## **PINEWOOD RIVER SUBDIVISION, BLOCK C, FIRST ADDITION TO, RESUBDIVISION OF LOT 10,**

Engineering Comments: FINAL PLAT COMMENTS (should be addressed prior to submitting the FINAL PLAT for review and/or signature by the City Engineer):

APPLICATION NUMBER 1 DATE March 2, 2023  
 APPLICANT Pinewood River Subdivision, Block C, First Addition to, Resubdivision of Lot 10  
 REQUEST Subdivision

# DETAIL SITE PLAN

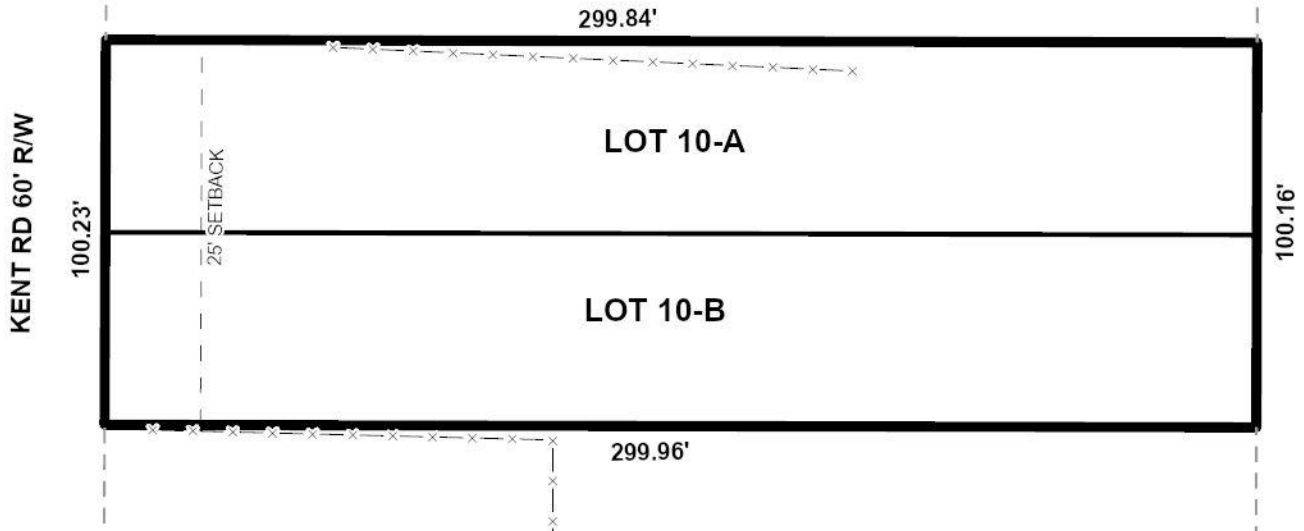
- B. Show and label the MFFE (Minimum Finished Floor Elevation) on each lot that contains an A, AE or X (shaded) flood zone designation. BFE = 12.
- C. Add a note to the SUBDIVISION PLAT stating that as shown on the 1984 aerial photo (FLIGHT 26 - #91) LOTS 10-A and 10-B will share the historical credit of existing (1984) impervious area towards stormwater detention requirement per Mobile City Code, Chapter 17, Storm Water Management and Flood Control). The lots will be allowed to add the following amount of impervious area before storm water detention is required: LOT 10-A – 1,000 sf, LOT 10-B – 3,400 sf.

The proposed site has frontage on Kent Road, a minor street without curb-and-gutter requiring a 60-foot right-of-way. The preliminary plat illustrates an existing compliant right-of-way at this location; thus, no additional dedication is required. As on the preliminary plat, the right-of-way width of Kent Road should be retained on the Final Plat, if approved.

The preliminary plat submitted illustrates a proposed 25-foot minimum building setback line along Kent Road, providing the minimum building setback line required by Section V.D.9 of the Subdivision Regulations. If approved, the 25-foot minimum building setback lines along Kent Road should be retained on the Final Plat.

The preliminary plat illustrates widths of 50-feet for both lots, which does not meet the minimum lot width requirements of Section V.D.2. of the Subdivision Regulations. Furthermore, the lots do not comply with the maximum width-to-depth ratio size set forth in Section V.D.2. of the Subdivision Regulations, with both lots approximately 125-feet too deep. The Subdivision regulations make exceptions to both of these requirements in the case of unusable land, which is not applicable to the subject site. There are no similarly configured lots in the area, therefore approval of the proposed subdivision may disrupt the character of the area. The applicant references future Subdivision Regulation requirements, but as they have not been yet adopted, the Planning Commission cannot consider the application using those standards.

*The site is located in a R-1, Single-Family Residential district with a Suburban Sub-district designation. Based on the Suburban Sub-district designation, per Section 6.C.2.(b)(2) of the Subdivision Regulations, lots shall be at least sixty (60)-feet wide at the building setback line. The*

*proposed lots are only 50-feet wide and thus are not compliant. Additionally, the width to depth ration requirements are still applicable, and again the proposed lots are not compliant.*

- 1) Proposed lot widths are less than the minimum standards of Section V.D.2. of the Subdivision Regulations;
- 2) Proposed lots exceed width-to-depth of Section V.D.3. of the Subdivision Regulations; and
- 3) The proposed lots are not in keeping with the character of the area.

- 1) The proposed lot widths are less than the minimum standards of Section V.D.2. of the Subdivision Regulations (Section 6.D.2.(b)(2)) of the "new Regulations);*
- 2) Proposed lots exceed the width -to-depth ration of section V.D.3. of the Subdivision Regulations (Section 6.D.3. of the new Regulations); and*
- 3) The proposed lots re not in keeping with the character of the area.*
